Addendum #1

A D D E N D U M N O . : 0 1

Project Name:	Metropolitan Library
Project Number:	11165

This addendum forms a part of the Contract Documents and modifies the original "Revised Pricing Documents" dated 05/28/14.

SHEET NO:
ASD 03
 ADDENDUM 01

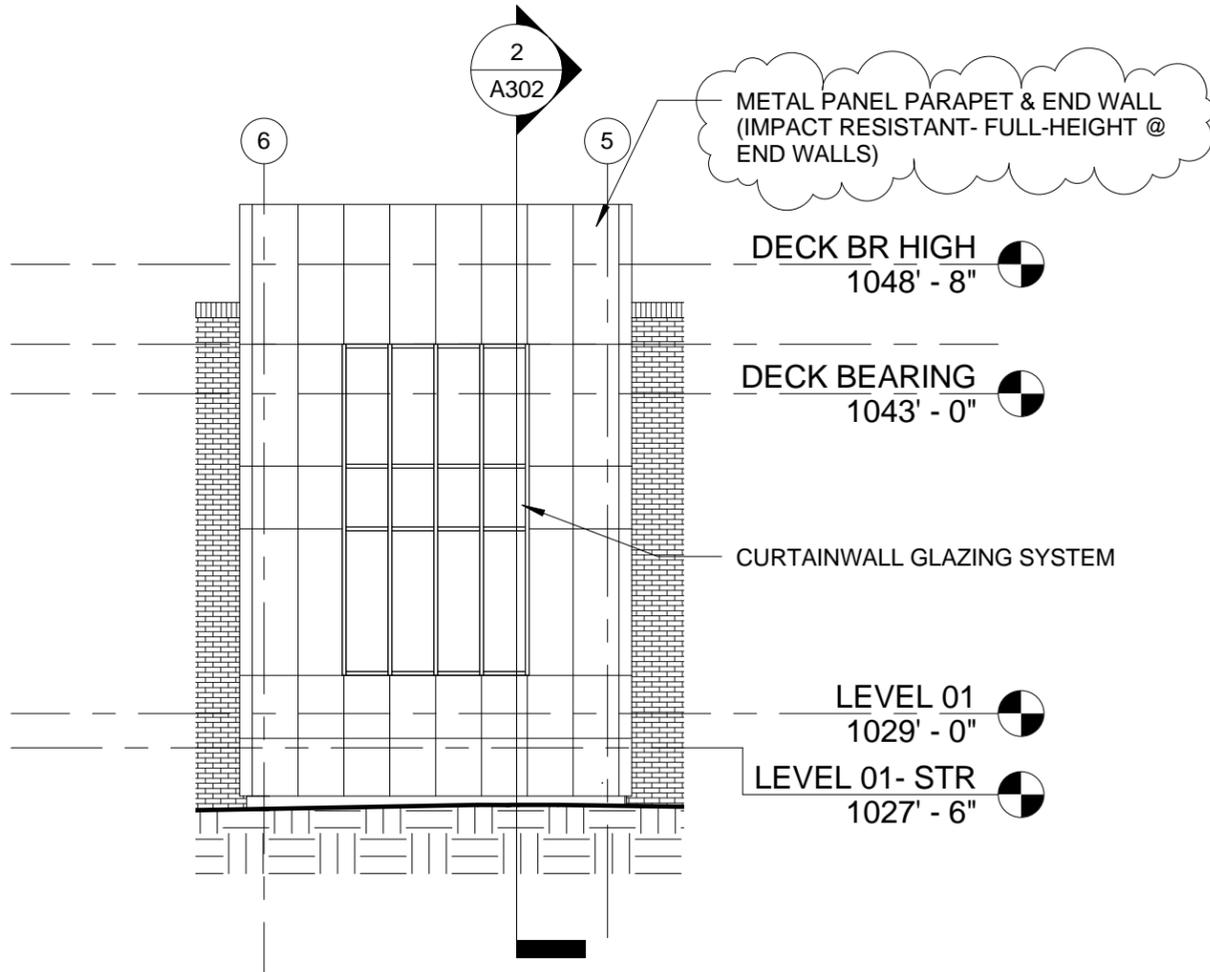
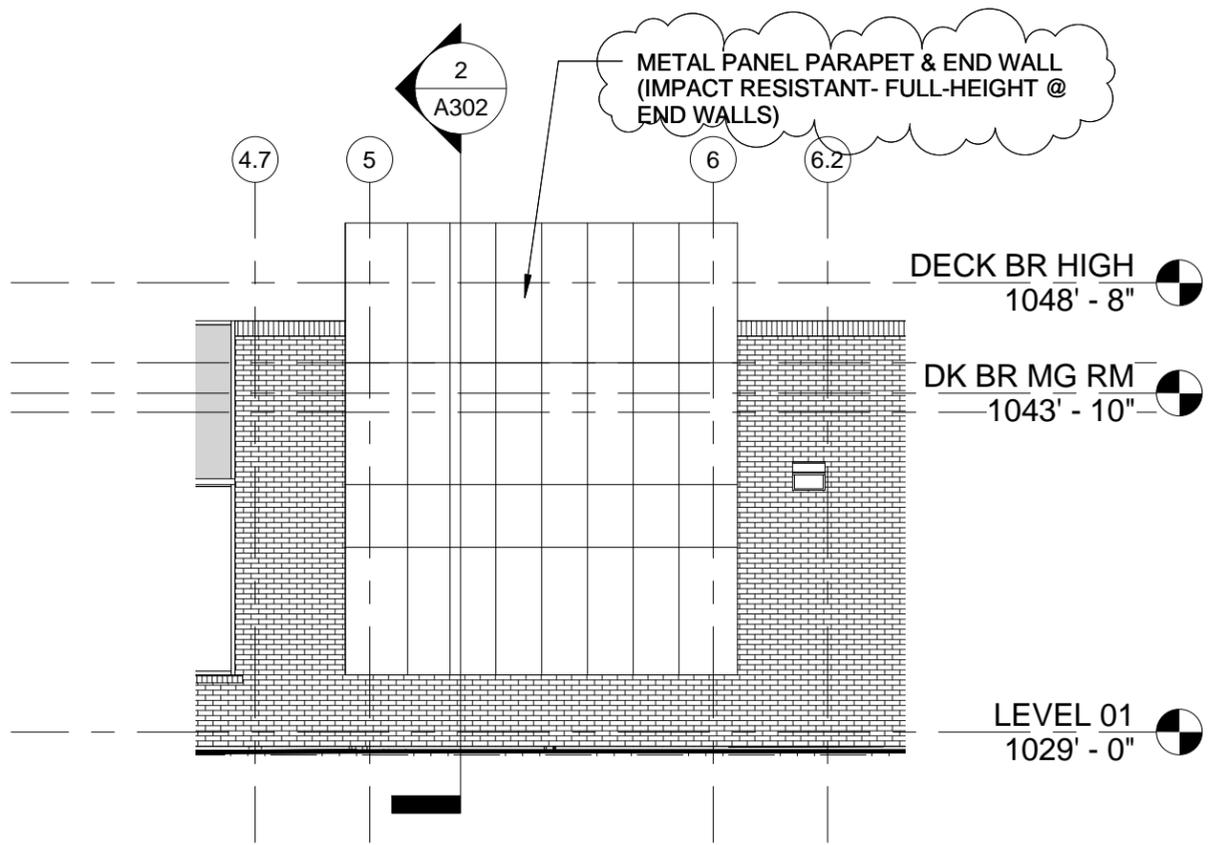
6. **A500 & A700-** Stainless Steel corner & edge guard/transition to be added to wood paneled wall (Refer to 9-10, 13-14/A700 & detail 5/A500). Also the plan detail for 5/A500 has been modified to reduce the amount of wood paneling, and make transition back to drywall at the Expansion Joint. See ASD 3.

SS INTEGRAL EDGE
 GUARD/TRANSITION STRIP,
 TYP @ EXPOSED EDGE OF
 WD PANELED WALL

SS INTEGRAL OUTSIDE
 EDGE/CORNER GUARD,
 TYP @ WOOD PANELED
 WALL EDGES (AT WALLS
 AND SOFFIT EDGES).

1 PARTIAL NORTH ELEVATION
 ASD 01 SCALE: 1/8" = 1'-0"

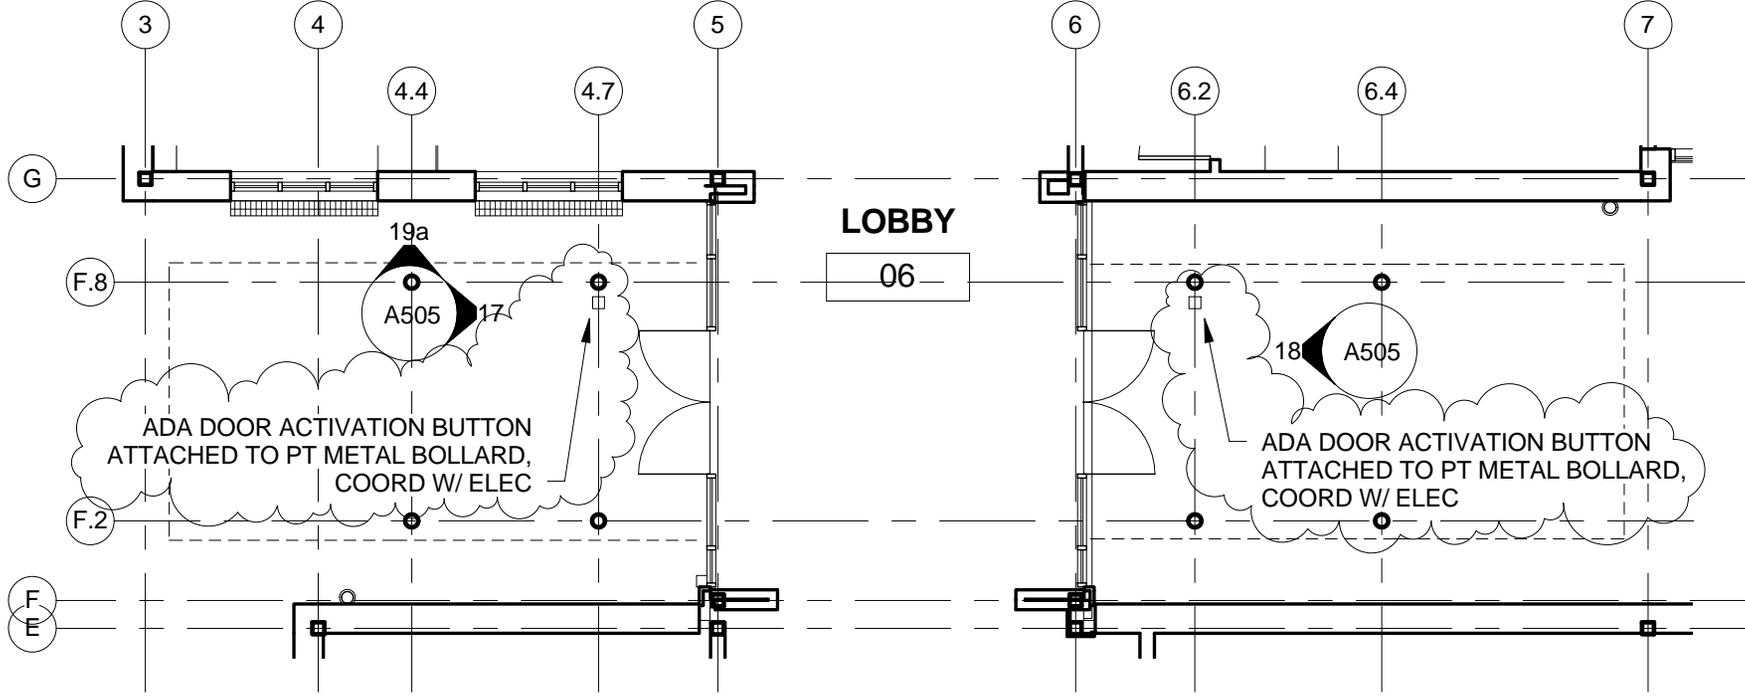
4. **2 & 4/A300-** End paneling on walls of Metal Panel spine to be Impact-Resistant panels. See attached ASD 01.
5. **A101-** ADA button for Entry doors to be attached to bollard, and not on building wall. This also impacts E111 junction box locations. See ASD 02.

SHEET NO:
ASD 04
 ADDENDUM 01

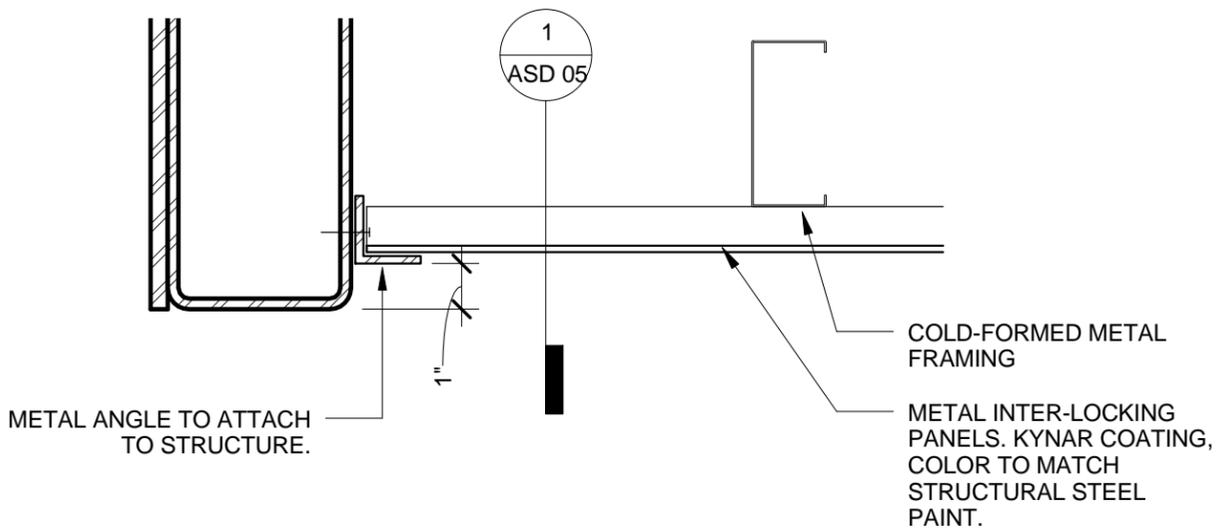
7. **1/A504-** Add metal panel to underside of Free Standing Canopy, lighting to be flush with outside of panel. See updated detail on ASD-04.
8. **15/A713-** Change support of Women, Men, & Family vanity to be with a painted, steel frame (with intermediate steel supports angled back, bolted back to wall) in place of Plam brackets support.

SUPPLEMENTAL DRAWING
 METAL PANEL CEILING ADDED TO
 FREE-STANDING CANOPY
 SCALE: 3/4" = 1'-0"

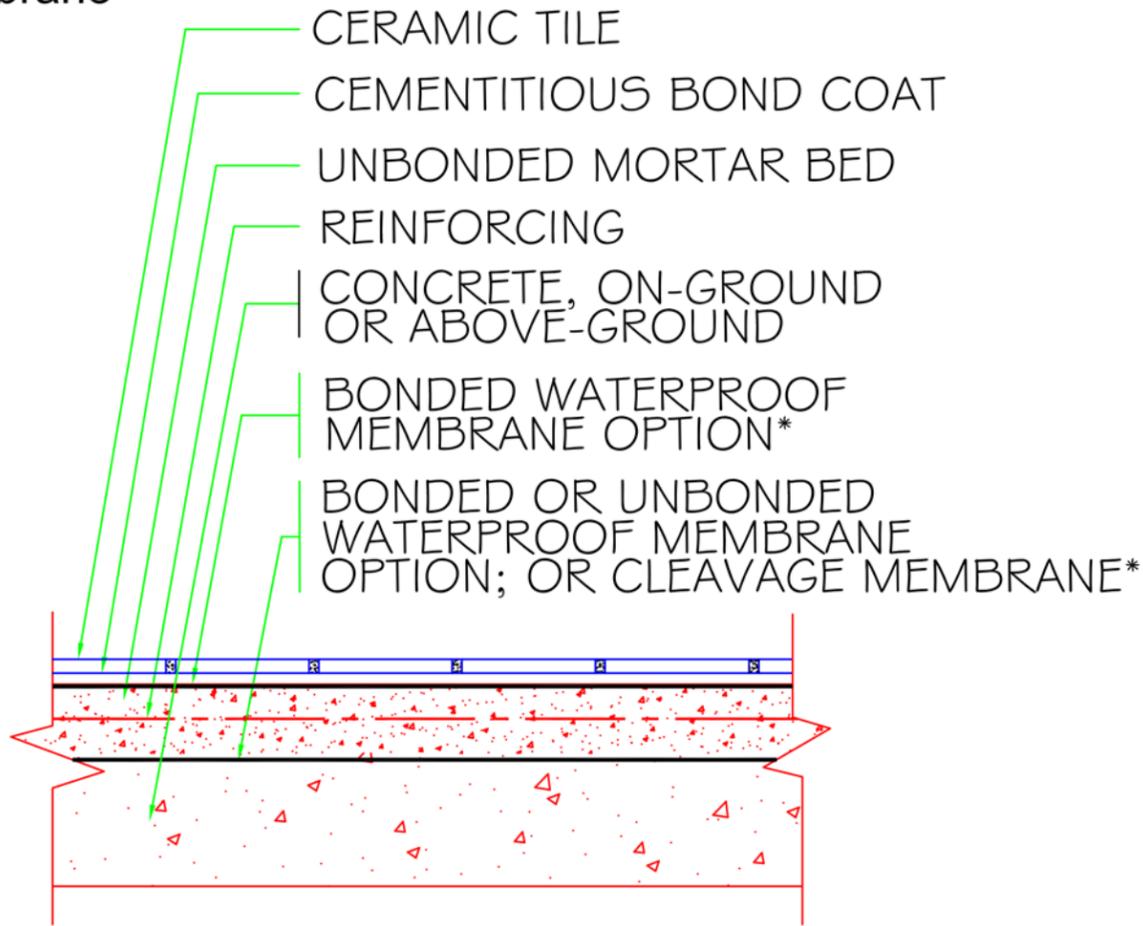
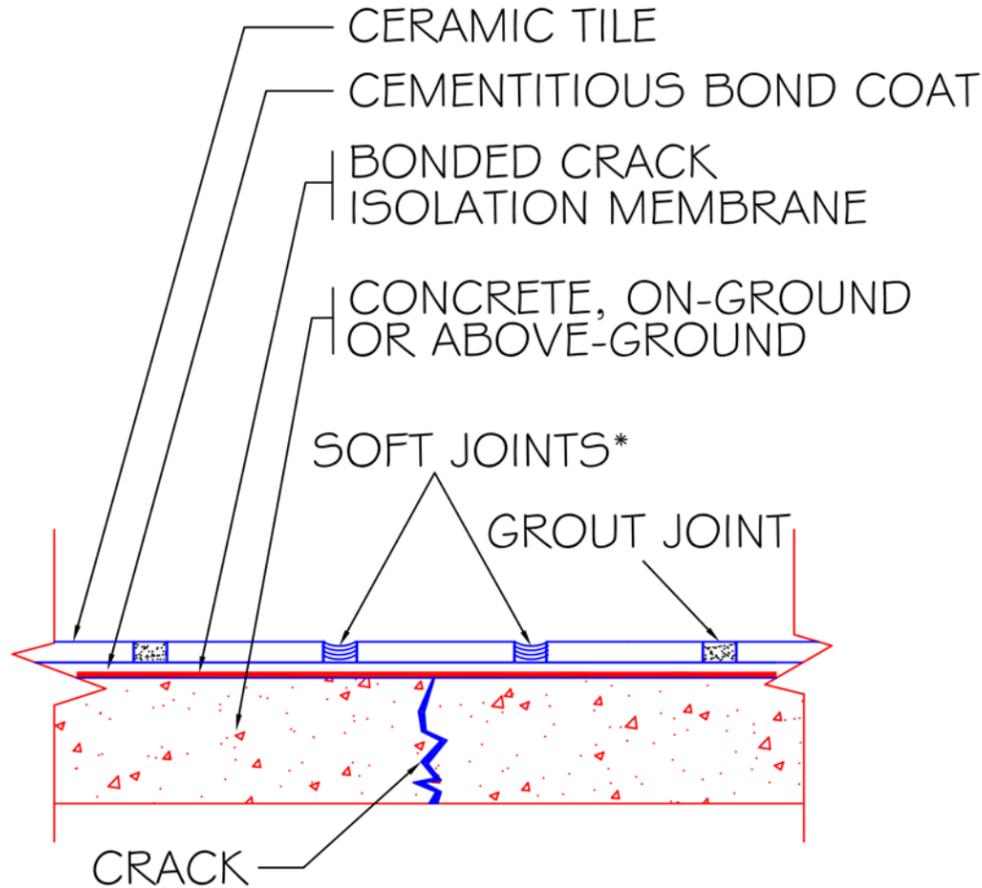
1. 07 1400 Fluid-Applied Waterproofing (new section).
2. 07 5400 Thermoplastic Membrane Roofing- Change to Insulation.
3. 09 3000 Tiling. Installation methods updated, see 09 3000 2.05, 3.04, & 3.05. Tile dap-out details are included in ASD 05.
4. 22 4000-2.03B Specification for Lavatory LV-1 to be changed to Kohler K-2330-0, White.
5. 22 4000-2.03B Specification for Water Cooler ECW-1 to be changed to Elkay EZSTL8WSLK EZH20 Bi-Level Unfiltered Water Bottle Filling Station, or similar to provide a Bottle Filler integrated into the water cooler.

- A. Over interior concrete substrates, install in accordance with TCNA (HB) Method F125-Full, with standard grout, unless otherwise indicated.
 - 1. Use uncoupling membrane under all tile unless other underlayment is indicated.

- A. Over interior concrete substrates, install in accordance with TCNA (HB) Method F121, unless otherwise indicated.
 - 1. Where waterproofing membrane is indicated, with standard grout or no mention of grout type, install in accordance with TCNA (HB) Method F121.
- B. Cleavage Membrane: Lap edges and ends.
- C. Waterproofing Membrane: Install as recommended by manufacturer and as specified in the section in which the product is specified.
- D. Mortar Bed Thickness: 1-1/4 inch (31 mm), unless otherwise indicated.
